The Network Rail (Leeds to Micklefield Enhancements) Order

CD 8.04 – Rebuttal Proof of Evidence – Jim Pearson

**REBUTTAL PROOF OF EVIDENCE OF ENVIRONMENT
OF
JIM PEARSON**

Document Reference	CD 8.04
Author	Jim Pearson
Date	20 February 2024

Figure 1: Tree bat surveys (reproduced from ER Volume 2 Figures: Figure 7.2.2)

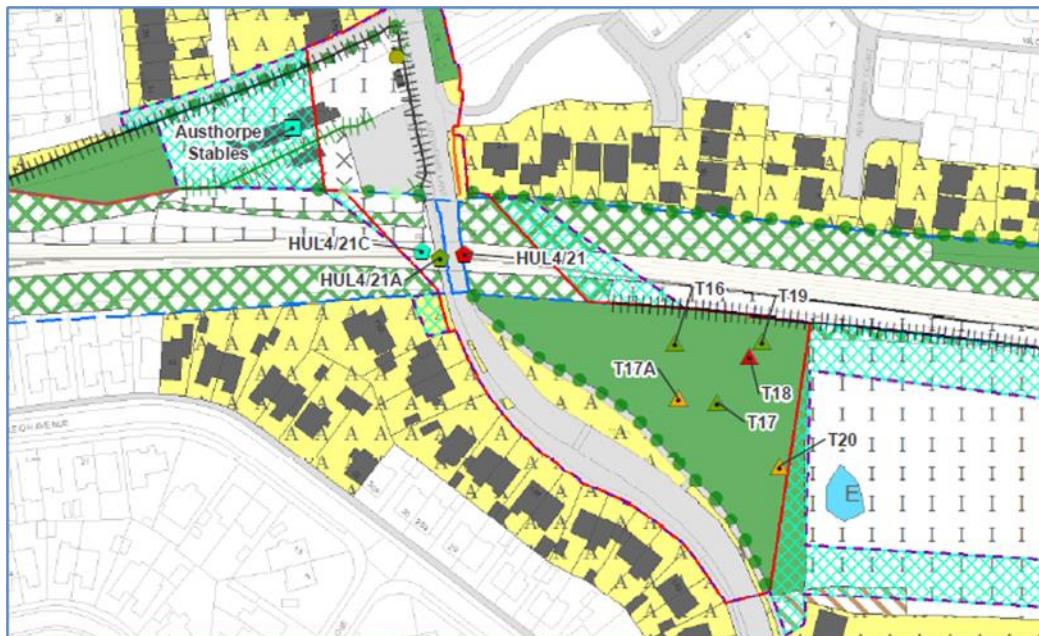
"From my own observations, and the observations of other local people familiar with this small piece of woodland, it is also home to at least one species of bat, although I have been unable to ascertain which species".

- 3.1.3 This resulted in tree climbing surveys for trees considered of "moderate" status or above conducted in this area on February 28th and March 1st 2023. In addition, bat surveys (dusk emergence and dawn re-entry) were completed between May and September 2022. In addition, further surveys were conducted on trees T18 and T20 that were originally unsafe to climb, as shown below in Figure 1 below, during May 2023 and June 2023.

- 3.1.4 The full and comprehensive suite of surveys resulted in a classification of each tree in terms of potential for bats to roost but did not identify evidence of actual bat roosting in this area of woodland.
- 3.1.5 This summary is taken from the detailed description of the methodology and results of the bat surveys as provided in the ER in Volume 3 Appendix 7.B and 7.C respectively.

- 3.1.6 As a precaution, but in the absence of any evidence of roosting bat activity in the woodland, all trees of moderate status or above (T17A, T18 and T20 from Figure 1), will be re-surveyed in advance of any works to prune back or remove trees as may be necessary to conduct the Order works. All trees that will require treatment, will be pruned back and / or removed in accordance with Bat Conservation Trust Guidance (Collins 2016), irrespective of classification for roosting potential as a precaution.
